Cylinder Head Bolts: Technical Service Bulletins

New Cylinder Head Bolt - Service Tips

95-3-10

ENGINE - 5.0L - NEW TORQUE-TO-YIELD CYLINDER HEAD BOLT KIT AND NEW PROCEDURES - SERVICE TIP

Figure 1

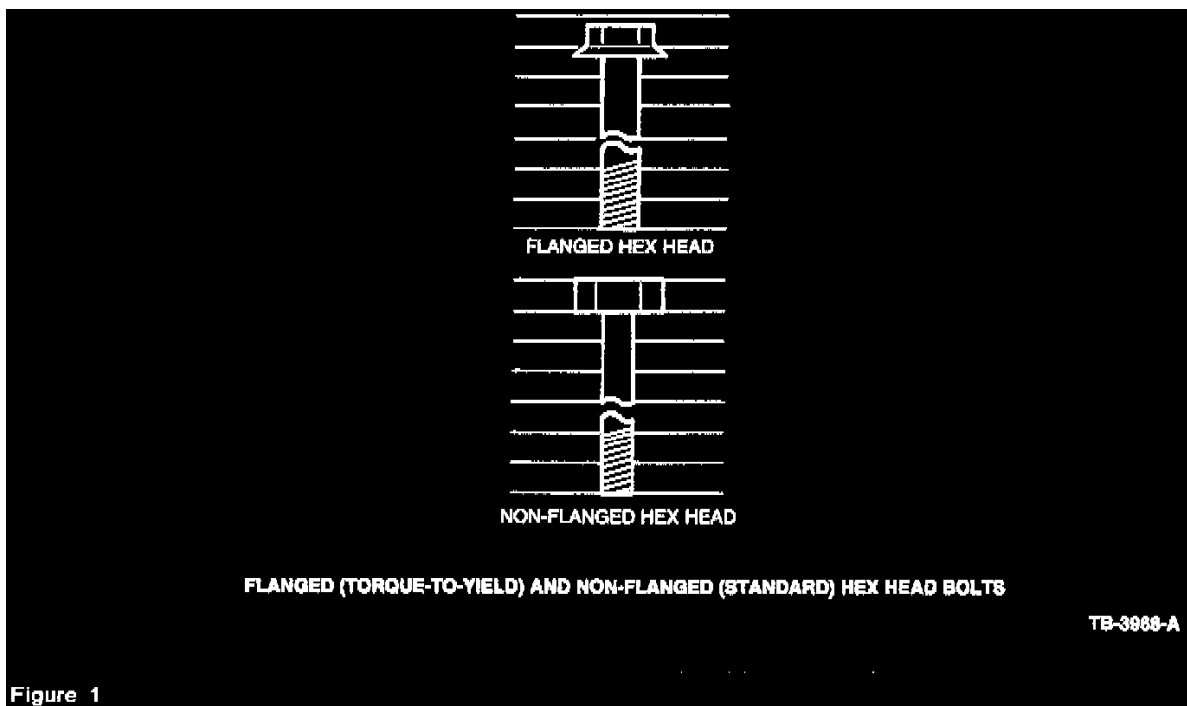
In 1992, the type of cylinder head bolts used on the 5.0L engines was changed to the torque-to-yield bolts. Depending on the build date of the engine, the 1992 model year engines came with either torque-to-yield bolts or standard torque, not a combination of the two (2). In 1993, torque-to-yield bolts were used on all 5.0L engines.

^ The two (2) types of bolts being used are physically different. Refer to Figure 1.

^ The standard torque bolt is a non-flanged hex head bolt.

^ The torque-to-yield bolt is a flanged head bolt.

^ The bolts must be all the same style on each cylinder head.

DO NOT USE BOTH TYPES OF CYLINDER HEAD BOLTS ON ONE (1) CYLINDER HEAD. EACH CYLINDER HEAD MUST HAVE

ALL OF ONE (1) TYPE OF RETAINING BOLT: STANDARD TORQUE OR TORQUE-TO-YIELD.

Figure 2

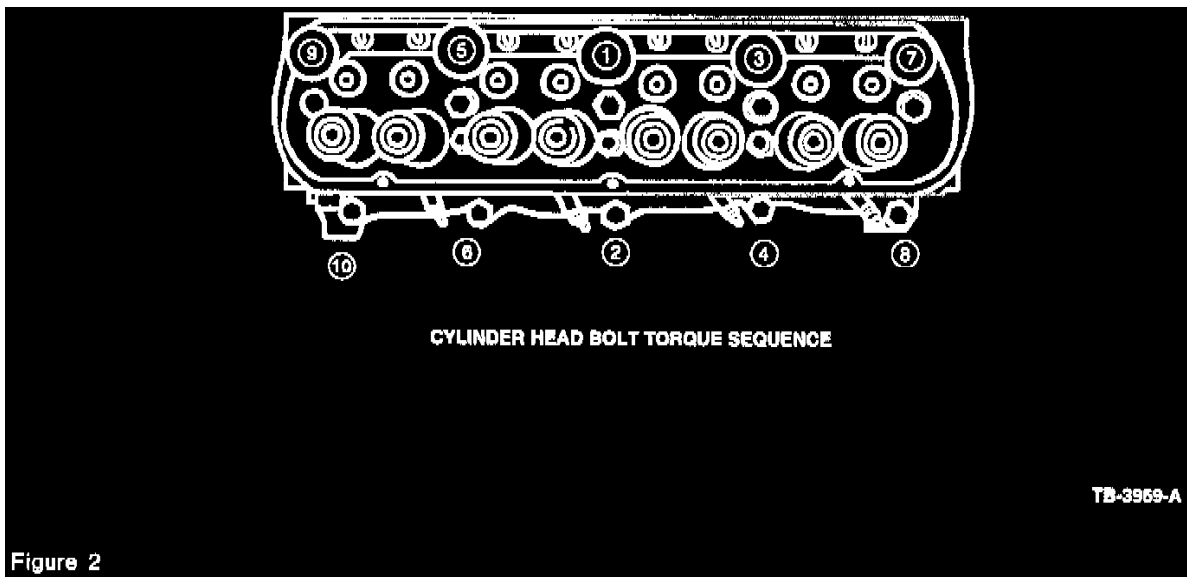
FOR THE NON-FLANGED STANDARD HEX HEAD BOLTS, TIGHTEN IN TWO (2) STEPS AS FOLLOWS:

FOR ALL TORQUE TO YIELD HEX HEAD BOLTS, TIGHTEN IN THREE (3) STEPS AS FOLLOWS:

1. Tighten all bolts in sequence (Figure 2) to 75-88 N-m (55-65 lb.ft.).
2. Tighten all bolts in sequence (Figure 2) to 88-98 N-m (65-72 lb.ft.).

1. Tighten all bolts in sequence (Figure 2) to 34-47 N-m (25-35 lb.ft.).
2. Tighten all bolts in sequence (Figure 2) to 61-75 N-m 45-55 lb.ft.).
3. Tighten all bolts in sequence (Figure 2) an additional 1/4 turn (85-95 degrees).

CAUTION:
TORQUE-TO-YIELD CYLINDER HEAD BOLTS MUST BE REPLACED WITH NEW BOLTS. DO NOT REUSE TORQUE-TO-YIELD BOLTS. TORQUE-TO-YIELD BOLTS MAY ONLY BE USED ONE (1) TIME.
